TO: SUPERSEDED BY EB 01-030 EFFECTIVE 5/30/01	<h1>ENGINEERING INSTRUCTION</h1> <p>NEW YORK STATE DEPARTMENT OF TRANSPORTATION</p>
Distribution: 31 Main Office 33 Regions 34 Special	Code: <u> EI 86-7 </u> Date: <u> 2/12/86 </u> Supersedes: _____
SUBJECT: ALTERNATE TETHER WIRE SIGN MOUNTING Subject Code: 7.27-2-645	
APPROVED:  <u>R. H. EDWARDS, Deputy Chief Engr., Fac. Des. Division</u>

SPAN WIRE SIGN MOUNT

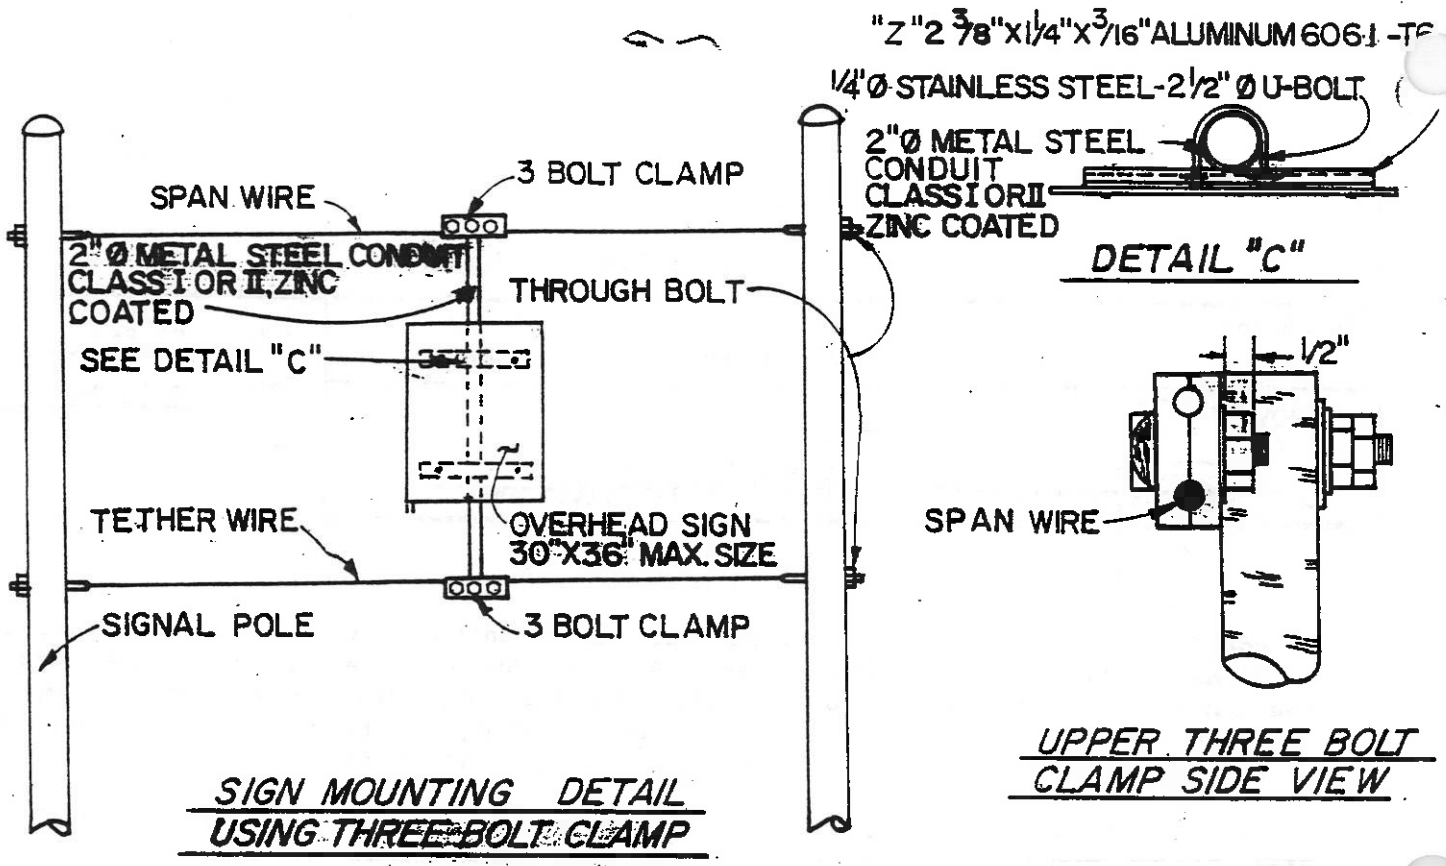
Standard Sheet 680-6 details the hardware and mounting that are normally used for mounting signs between tether wires. An employee's suggestion was made through the Suggestion Committee to allow alternate mounting hardware as detailed on the attached sketch. This revised hardware and mounting detail have now been approved as an acceptable alternate to the standard detail shown on SS 680-6.

ADD THE FOLLOWING DETAIL TO STANDARD SHEET 680-6 WHEN TETHER WIRE IS USED

A copy of this drawing detailing this alternate will be added as a note by the Final Plan Review Bureau to proposals listing Item 645.07. It is expected that this alternate will be added to the Standard Sheet in the future. This will become effective with the Letting of June 26, 1986.
